City of Alexandria, Virginia

MEMORANDUM

FROM: KARL MORITZ, DIRECTOR, PLANNING AND ZONING

SUBJECT: MARINO'S EXTENSION: FRONTEAGE CONDITIONS

ATTACHMENT 1: ORIGINAL APPROVAL

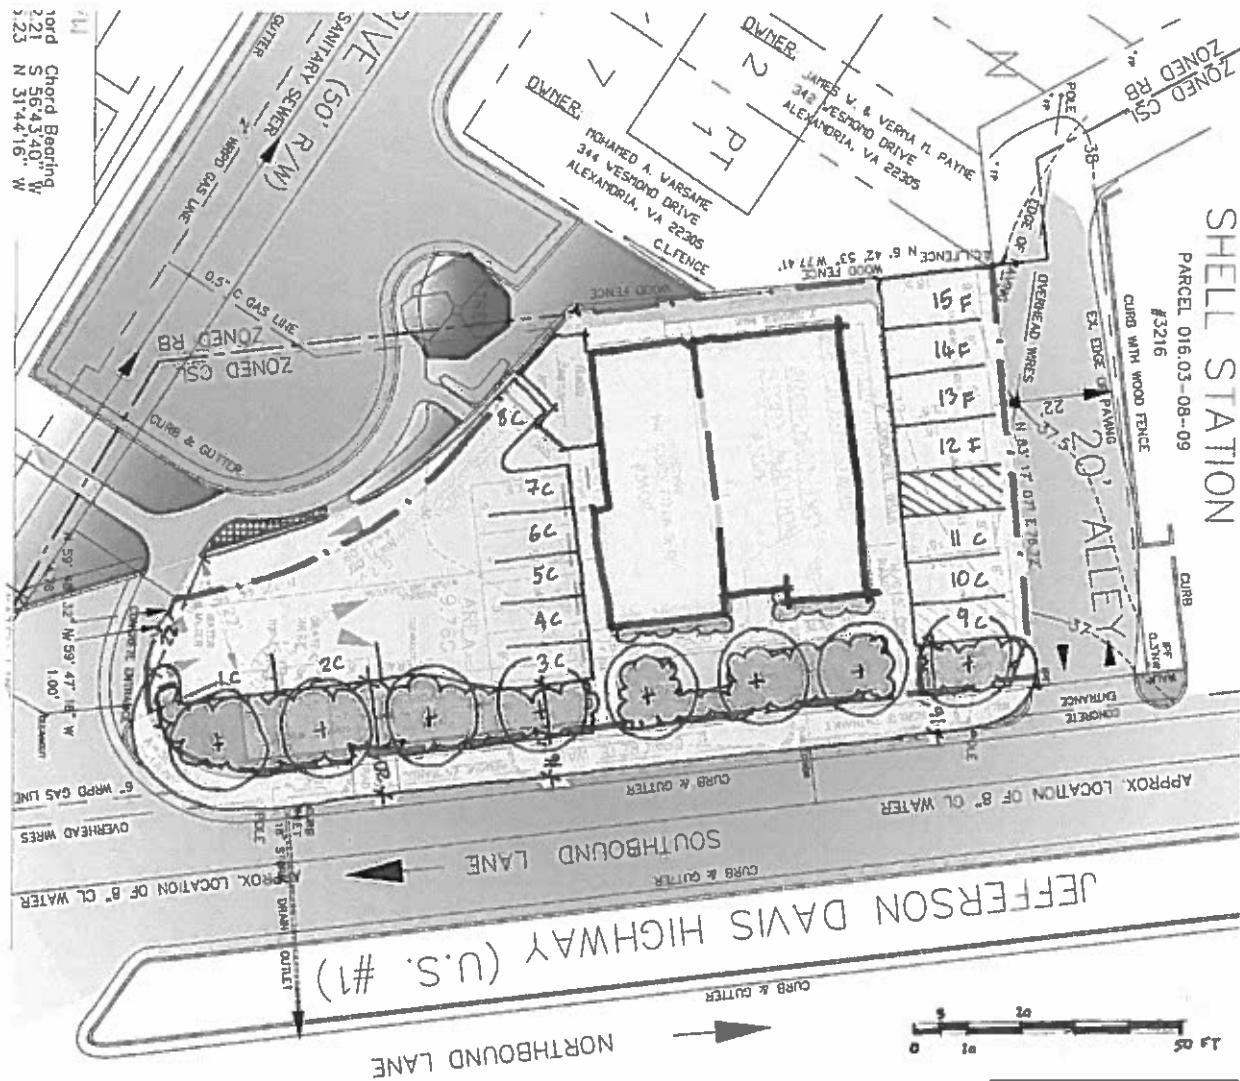
- Staff was able to reach agreement with the applicant to revise the parking area and reduce it by one space (with a corresponding reduction in seating) to achieve a larger landscape area along the frontage.

- The larger landscaped frontage is equivalent to the area staff sought to achieve through dedication or an easement. This configuration allows future pedestrian improvements to be completed without impacting buildings or parking areas on the site and means that the Marino's expansion would not preclude future pedestrian improvements consistent with the upcoming Oakville Triangle Plan.

However, in light of the City Council and local community's interest in achieving an improved streetscape at this location, staff and the applicant have reached an agreement which revises the parking area of the proposal to provide a significantly larger area of landscape along the building frontage; helping to screen the parking and to provide a break between the adjacent paved areas of right-of-way and parking lot. This locates the parking area 16 to 20 feet back from the curb, equivalent to the area staff sought to achieve through dedication or an easement. This configuration allows future pedestrian improvements to be completed without impacting buildings or parking areas on the site. The revision reduces the parking provision by one space, which necessitates a reduction in restaurant seating by 4 seats (from 44 to 40) in order that the project can meet the parking requirements.

1. **CONDITION AMENDED BY STAFF:** The Final Site Plan shall be in substantial conformance with the preliminary plan dated November 15th 2010 (including supplemental information dated December 13th 2010, and the revised parking and landscape layout agreed with the City staff 24th January 2011 shown in Attachment #1 2) of the Memo from the Director of Planning & Zoning to City Council dated 31 March 2015, and the landscape plan agreed with City staff 31st July 2012 shown in Attachment #2 of the staff report and comply with the following conditions of approval.

4. **h CONDITION ADDED BY STAFF:** Add supplemental landscape to the frontage in general compliance with the Memo from the Director of Planning & Zoning to City Council dated 31 March 2015.

19. **CONDITION AMENDED BY STAFF:** Interior seating shall be limited to a maximum of 44- 40 (forty) seats. Outdoor dining shall be prohibited.
49. **CONDITION AMENDED BY STAFF:** Provide sixteen fifteen parking spaces (including one handicap accessible space, van-sized) in the on-site parking lot per Attachment #1-2 of the Memo from the Director of Planning & Zoning to City Council dated 31 March 2015.
